LOT LINE ADJUSTMENT AND CONSOLIDATION PLAN FOR AL-AHAD ISLAMIC CENTER

MINOR PLAN 2023-204

Al-Ahad Islamic Center Minor Plan #2023-204

Lot Line Adjustment Plan Review

LOT LINE ADJUSTMENT / CONSOLIDATION

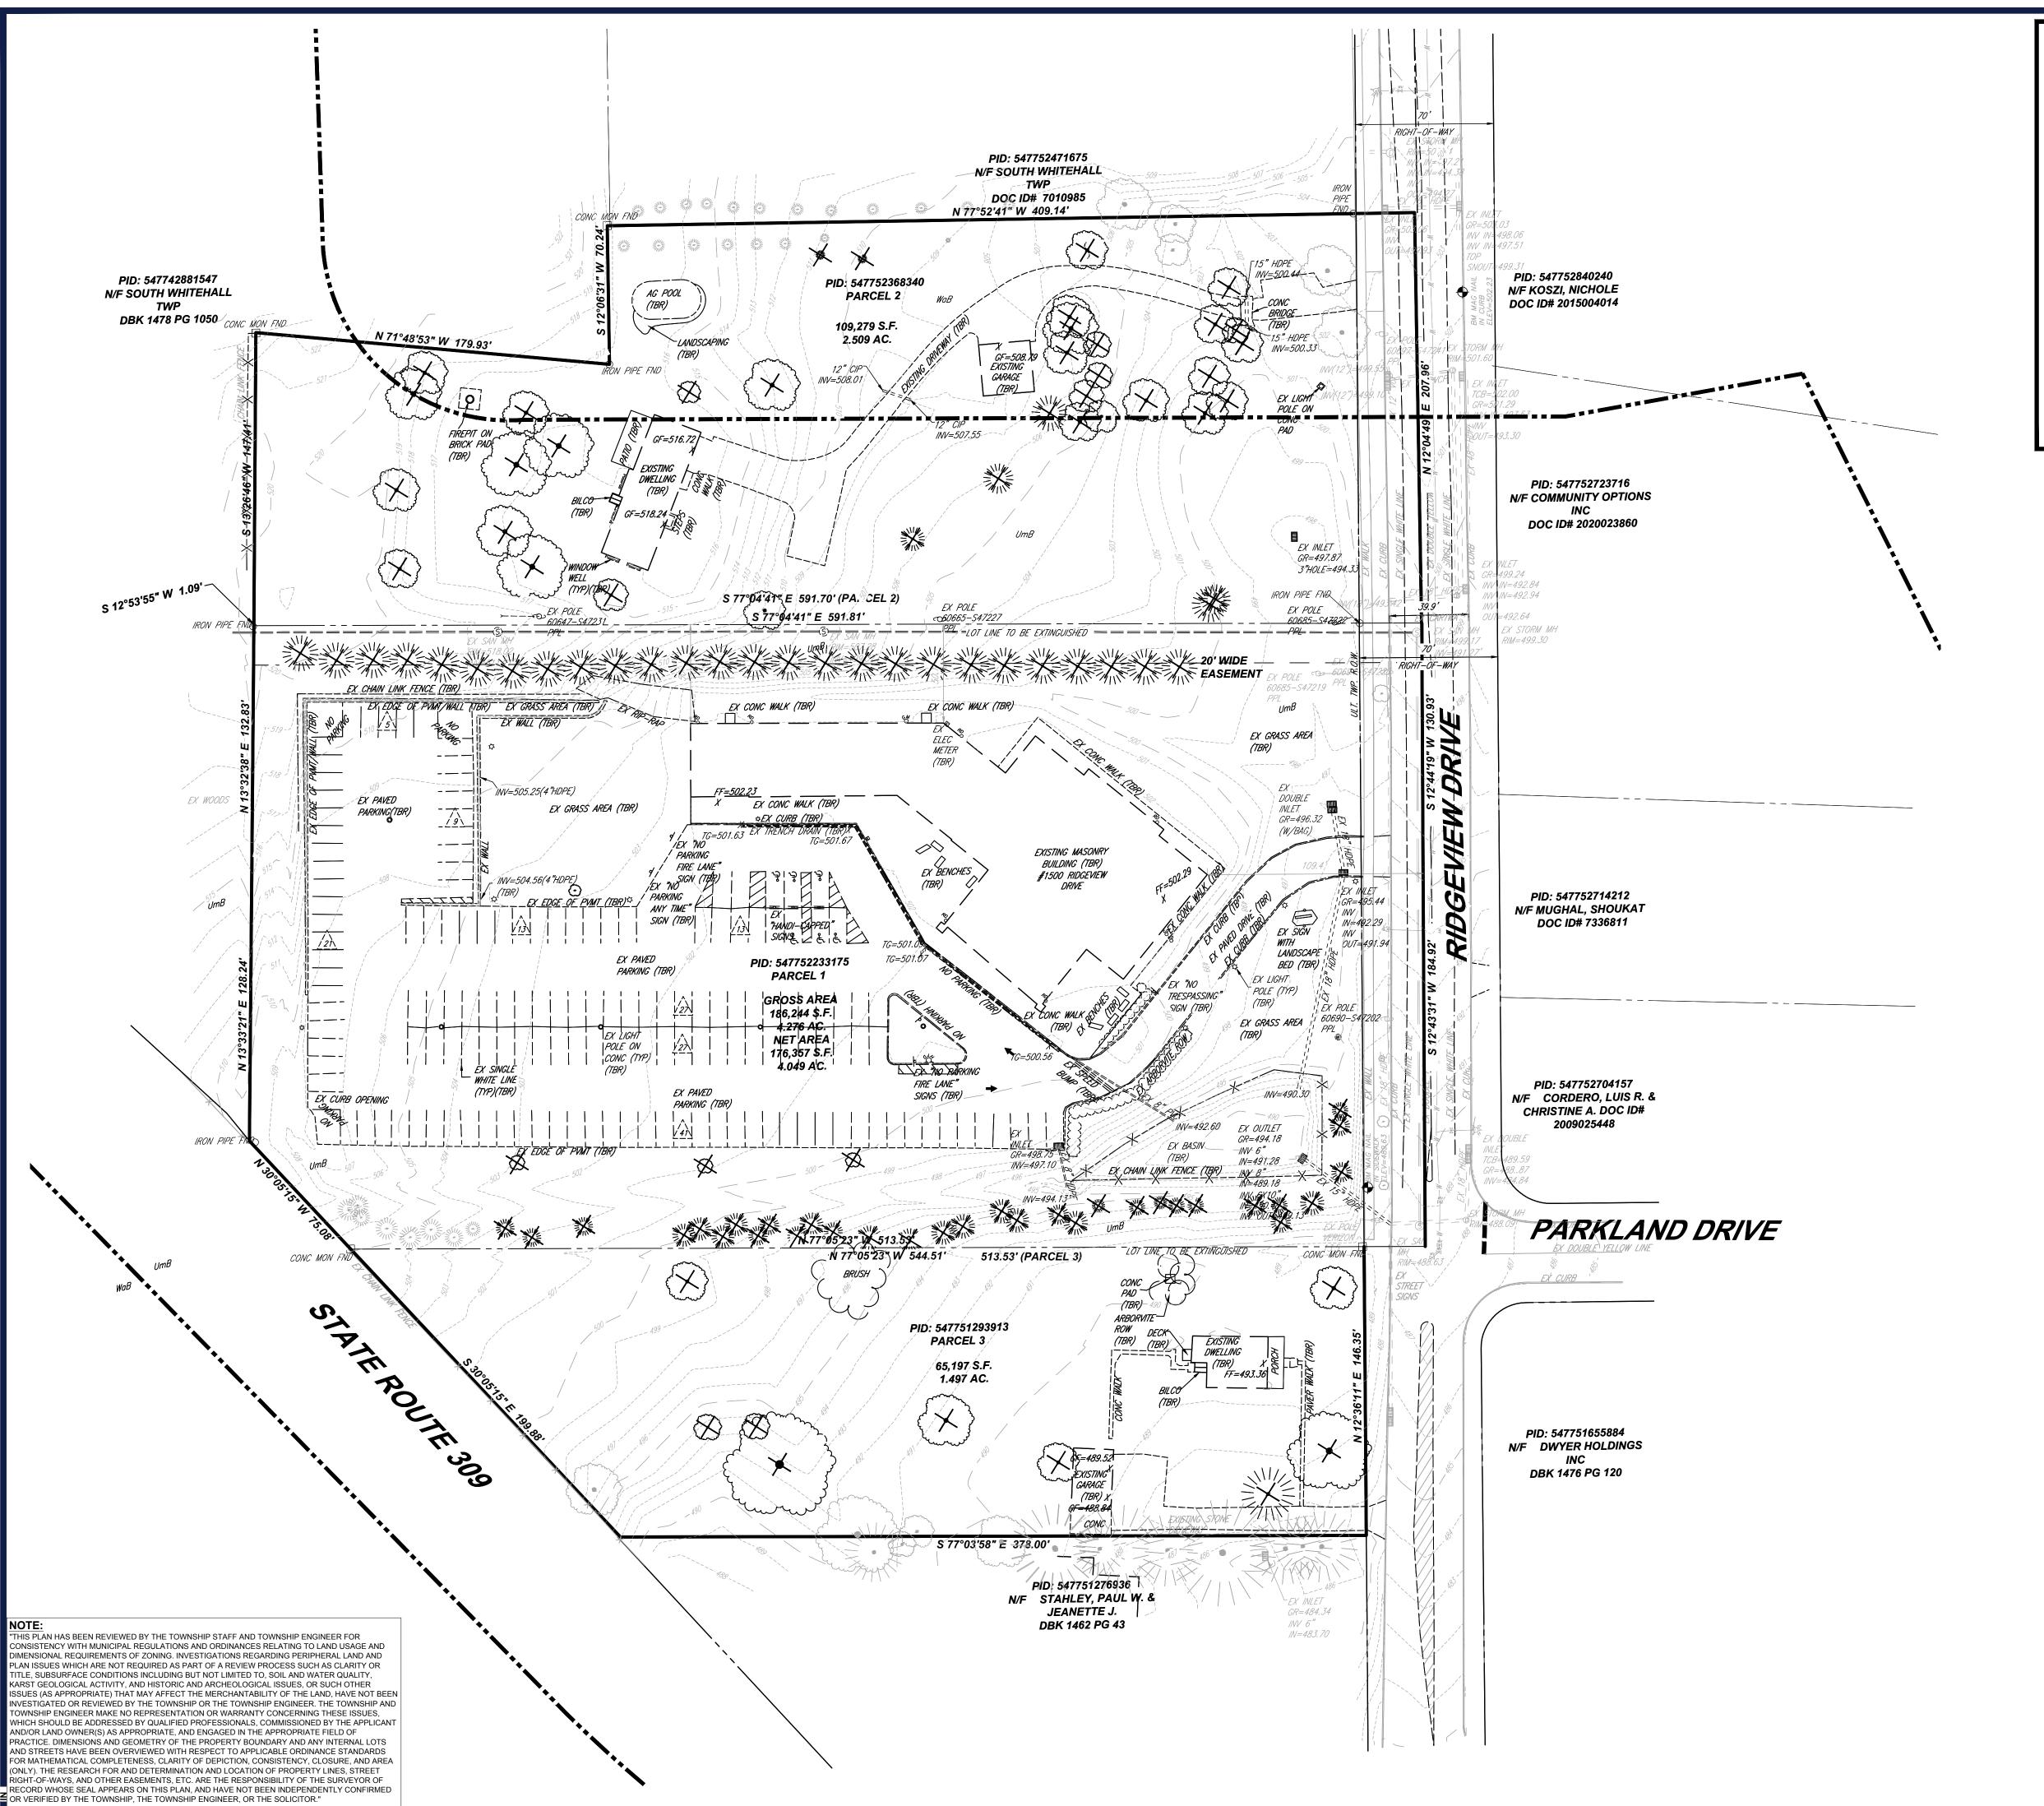
- 9. We defer to the Township Solicitor to review the acceptability of the Note on Sheet S-2 beneath the Zoning District Requirements Table; and
- 10. Revise the South Whitehall Township Planning Commission Recommendation for Approval block to be consistent with SALDO §312-22(d).

S-1

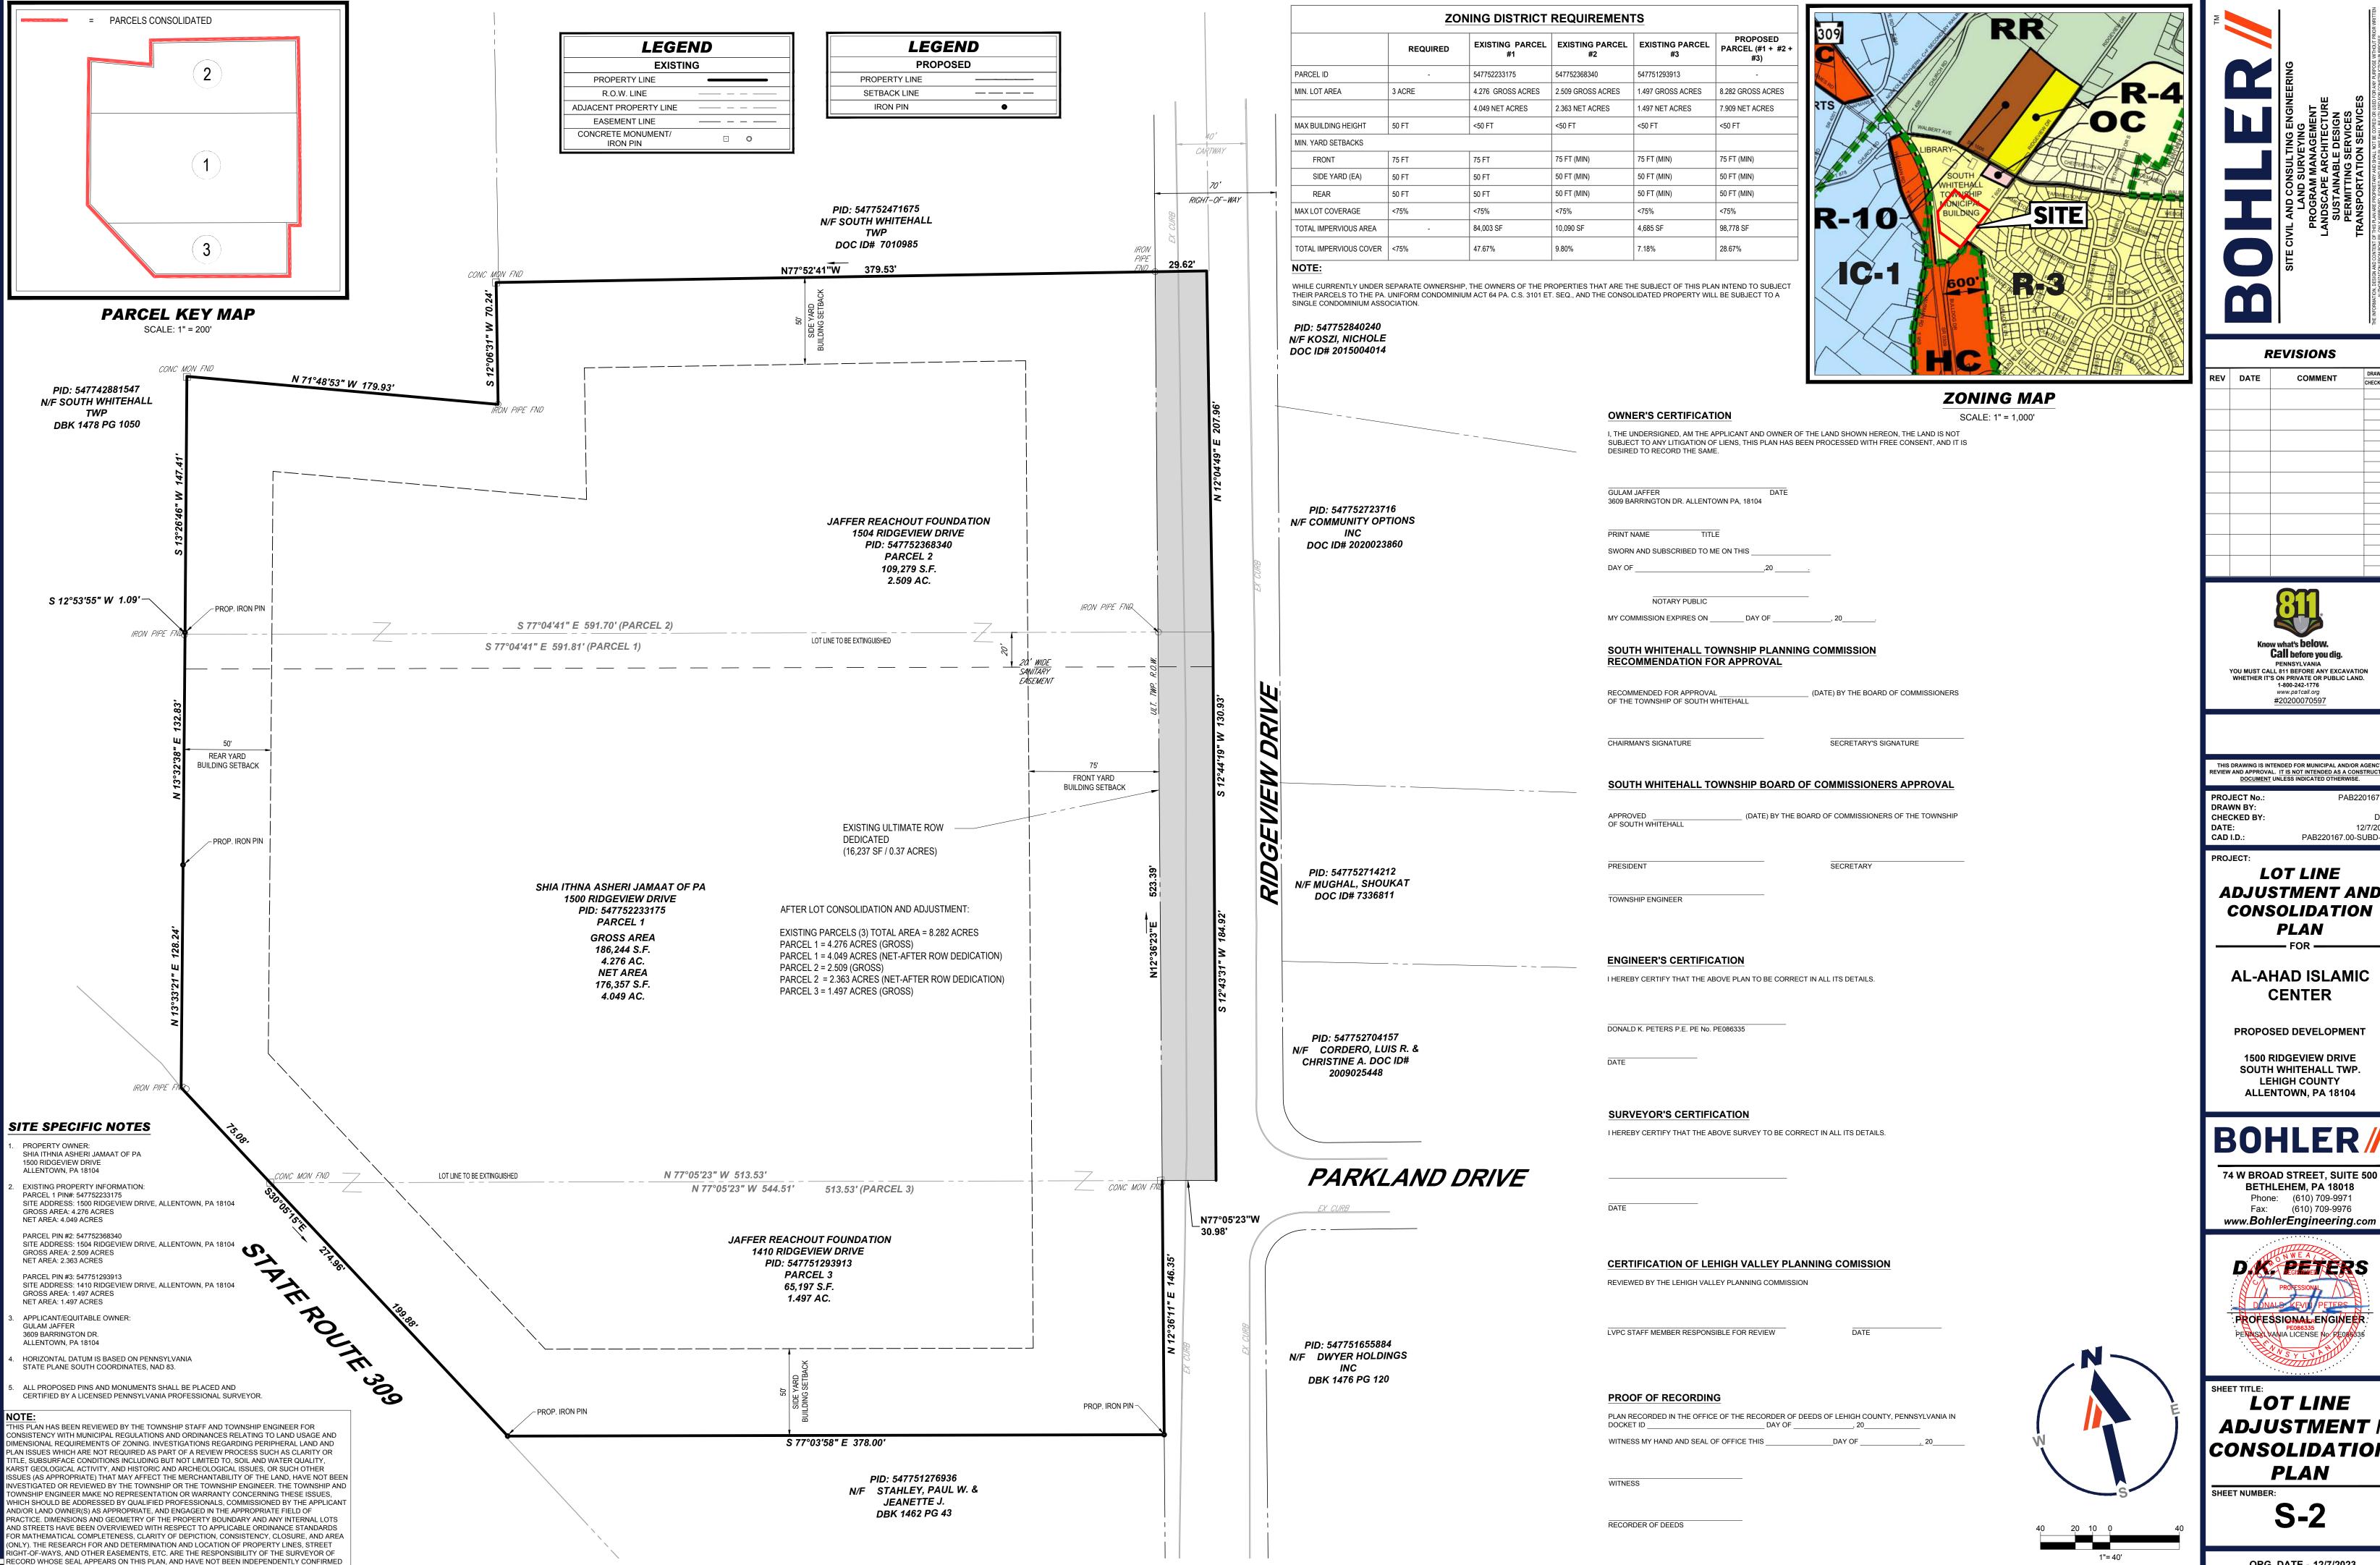
- d. Add Zoning Districts to the Location Map, SALDO §312-23(b)(11)(d);
 - e. Identify the location of the benchmark on the Plan, SALDO §312-23.B(16);
 - f. Show the locations, size and owners of existing buildings, sewer mains, water lines, etc., within 100 feet of the tract, SALDO §312-23(b)(19);

- 6. Provide existing easements on the Plans (e.g., water easements, PPL easements, etc.) and any supporting easement information (e.g., restrictions, access, etc.);

- 1. The sanitary sewer easement between 1500 Ridge View and 1504 Ridge View is 10' wide not 20' wide.
- 2. The owner shall notify the Township water/sanitary sewer billing department in writing of the billing account address changes for 1410 and 1504 Ridge View Drive.

1. Please indicate the sewer easement on the plan.
